PARTS & SERVICE NEWS

REF NO.	AT00204
DATE	Oct. 16, 2000

SUBJECT: REPAIR PROCEDURE OF ECMV FILL SWITCH ON WA1200-3

PURPOSE: To introduce modification procedures to repair the fill switch of the ECMV on WA1200-3 wheel loaders

<Fig. 1>

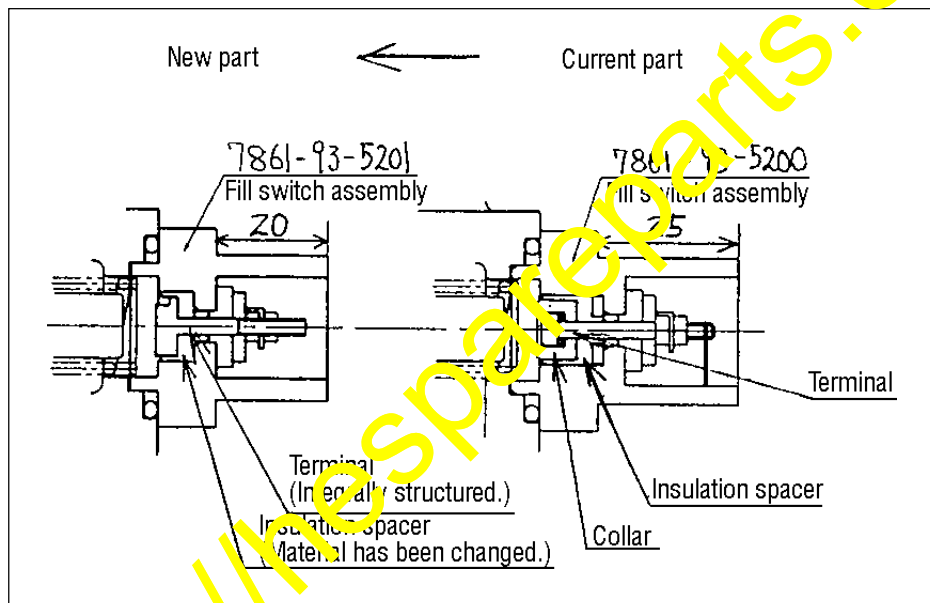
By making the following modifications, the conduction reliability of the fill switch has been improved.

- 1) The structure of the terminal has been changed to an integral structure to improve the conduction reliability of the fill switch.

New structure ←	Current structure
Terminal structure	Integrally structured terminal	Split structure of the collar and the terminal

- 2) The base material of the insulation spacer has been changed to cotton cloth having better joining property for the molded resin material.

<Fig. 2>

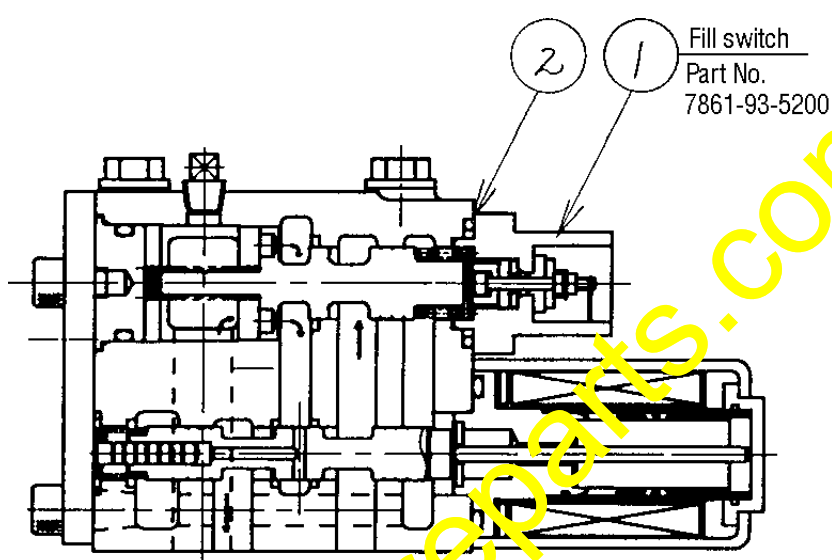
Before removing the fill switch, thoroughly remove mud and sand adhering to the ECMV to prevent entry of foreign substances.

- 1) Remove the fill switch ① and O-ring ② to make the state as shown in Fig. 3 below.

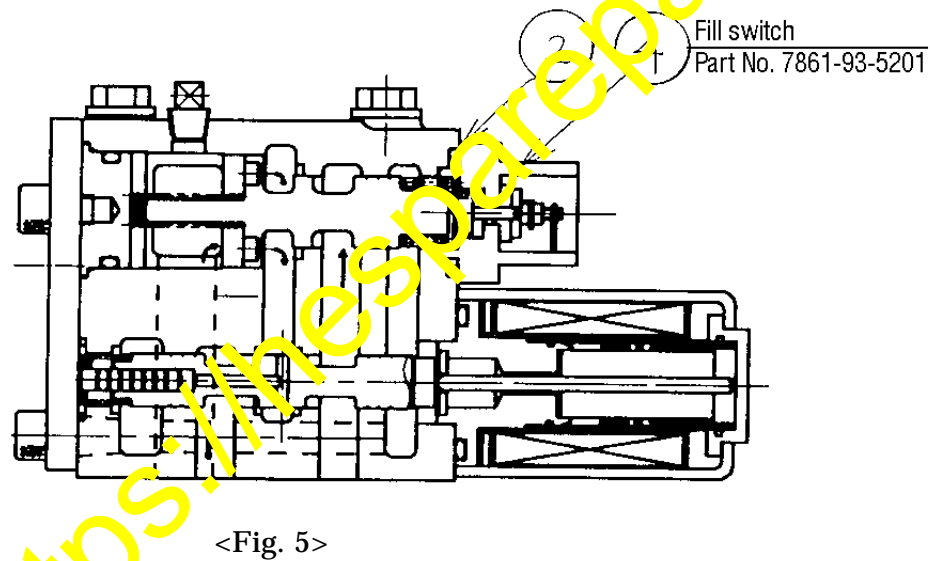
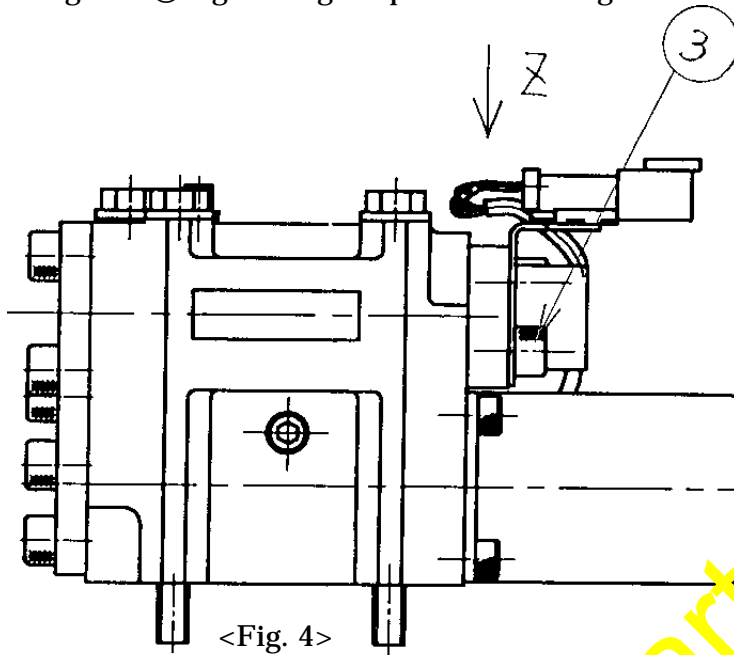
- 2) Install the improved fill switch ④ (Part No. 7861-93-5201).
 - Replace the O-ring ② with a new part.
 - Mounting bolt ③ tightening torque : 2.8 – 3.5 kgm

As shown in <Fig. 6> below, the part number (7861-93-5201) is stamped on the surface of the flanged section (hatched section shown in Fig. 6) of the fill switch.
